RFQ No. DHyE/CO/CPD/18/2023/1145 and RFQ No. DHyE/CO/CPD/18/2023/1146

Clarifications to the Queries of the Applicants for the Request for Qualifications for issue of Bidding Documents for the Main Civil Contract Packages of 90 MW Jomori HPP, 54 MW Gamri-I HPP and 26 MW Druk Bindu HPP.

Annexure 1-1: Project Layout

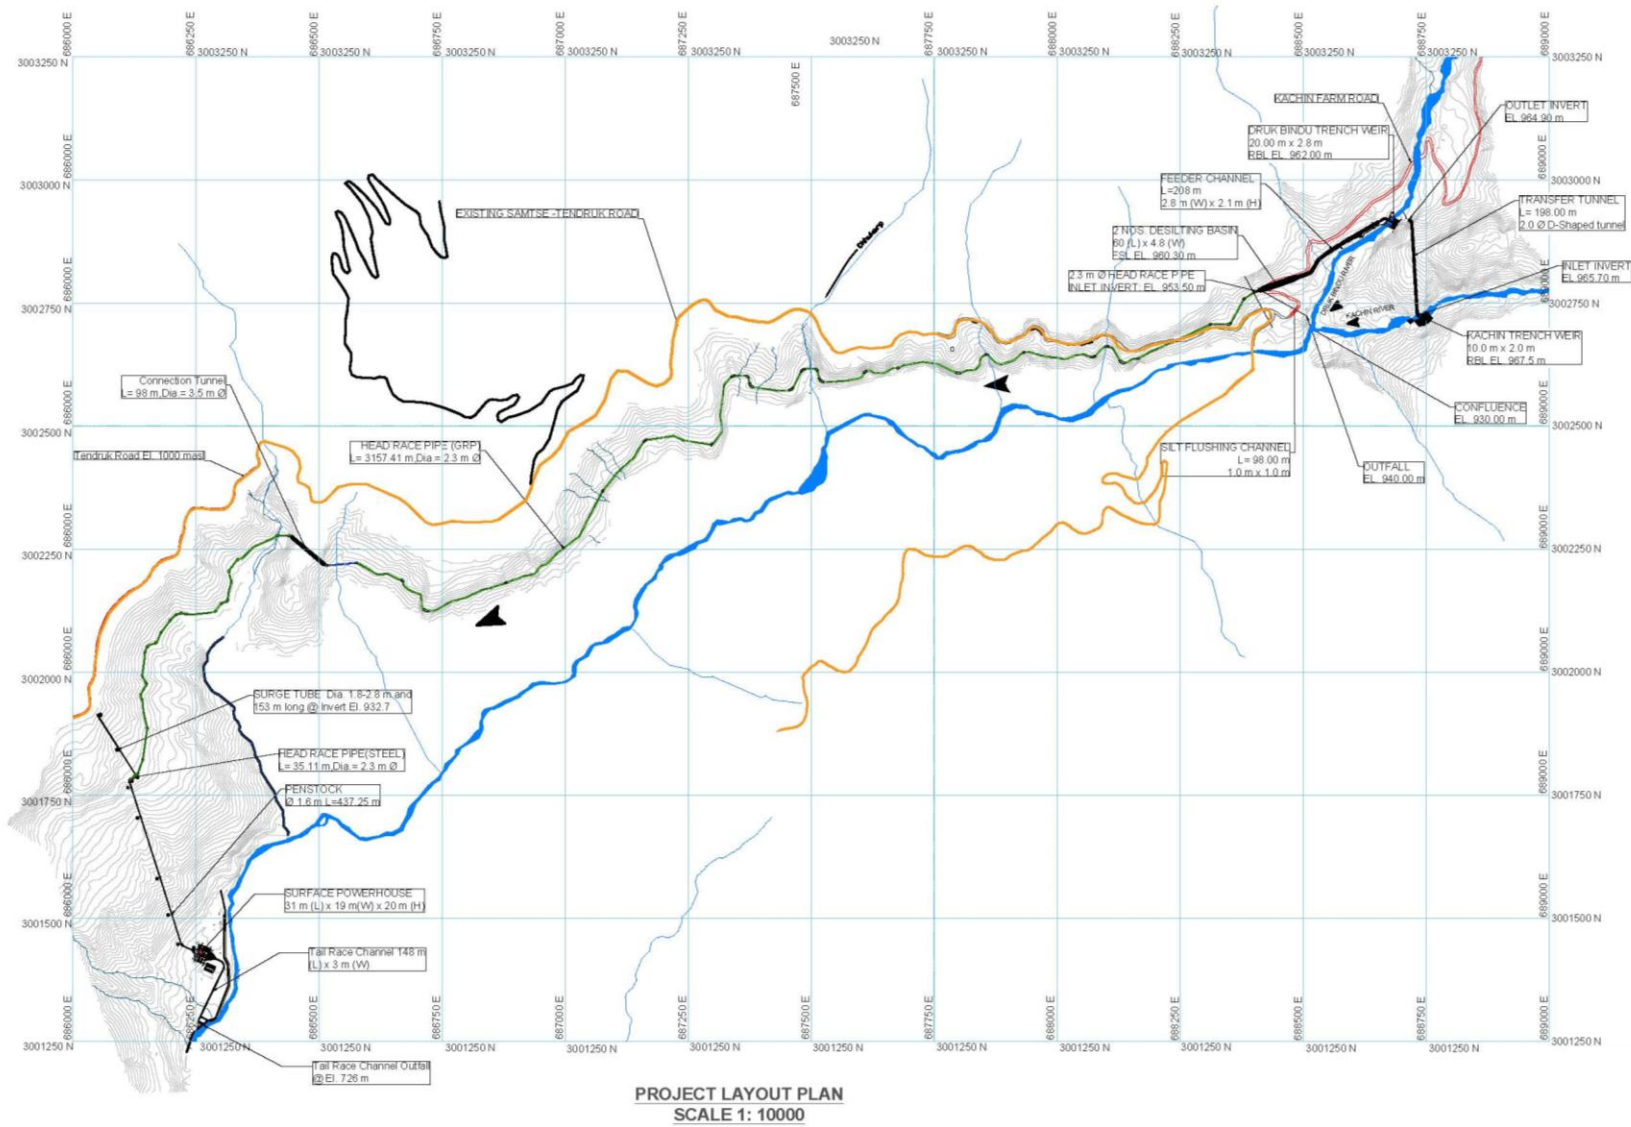
3	We would like to know if we can use hired machinery and if you would accept unaudited financial statements for the year 2023.	<p>Kindly refer the Format g), iv page 32 at SECTION-4 of the RFQ-A and Format 4.5.3 at page 33 of SECTION-4 of the RFQ-B.</p> <p>It is clearly mentioned that Documentary evidence of ownership is required to be submitted. Assessments shall be done for the owned machineries/equipment.</p> <p>Unaudited financial statement shall not be accepted.</p>
4	We would like to request you to kindly give us General Layout drawings.	To be provided as attachment to this Clarification.
